Access Compliance Report

Public Rights-of-Way

Intersection ID: 47643	Main Street: BAMBURGH_CT	Cross Street: WESTON_WOODS_LN	Location: NE
ADA ID: F015A3B4FFCA	Ramp Type: PerpDiag	Initial Pass/Fail: Fail	Overall Compliance: No
Severity Score: 13.75			
Codes/Mitigation Info/Possible Solution		Field Measurements/Component Compliance

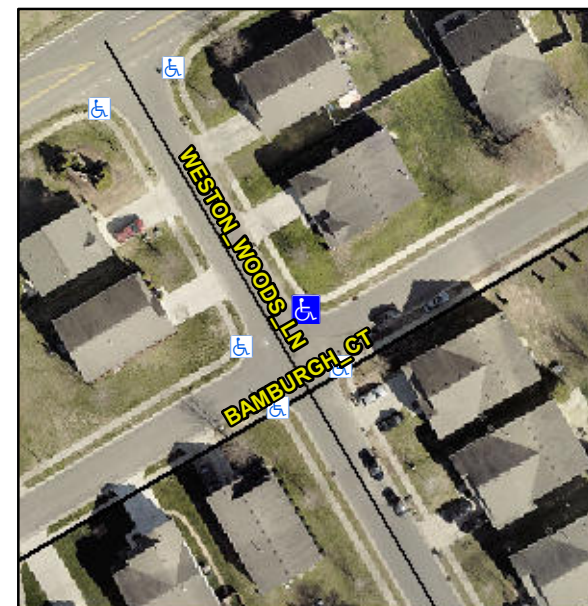
Not Found, R304.2.2, R304.5.3

Compliance	Description	Data	Compliance	Description	Data
N/A	Ramp Length (in)	48.0	No	Ramp Slope (%)	8.9
Yes	Ramp Width (in)	48.0	No	Ramp XSlope (%)	3.3
N/A	Flare Type LT	N/A	N/A	Flare Type RT	N/A
N/A	Flare Slope LT (%)	N/A	N/A	Flare Slope RT (%)	N/A
N/A	Flare Traversable LT?	N/A	N/A	Flare Traversable RT?	N/A
N/A	Landing Length (in)	N/A	N/A	DWS Provided?	N/A
N/A	Landing Width (in)	N/A	N/A	DWS Contrast?	N/A
N/A	Landing Slope (%)	N/A	N/A	DWS Length (in)	N/A
N/A	Landing X Slope (%)	N/A	N/A	DWS Full Width?	N/A
N/A	Landing Curb? (Y/N)	N/A	N/A	DWS Offset (in)	N/A
N/A	Shared Landing?	N/A			
N/A	Gutter Ponding?	N/A	N/A	Gutter Slope (%)	N/A
N/A	Gutter Lip Ht (in)	N/A	N/A	Gutter X Slope (%)	N/A
N/A	Painted X Walk1?	No	N/A	Painted X Walk2?	No
	X Walk 1 Direction	To SW		X Walk 2 Direction	To SE
N/A	X Walk 1 Width (in)	N/A	N/A	X Walk 2 Width (in)	N/A
	X Walk 1 Slope (%)	1.7		X Walk 2 Slope (%)	2.0
	X Walk 1 X Slope (%)	0.1		X Walk 2 X Slope (%)	3.2

Remove & Replace Curb Ramp With Two New Directional Ramps or Equivalent.
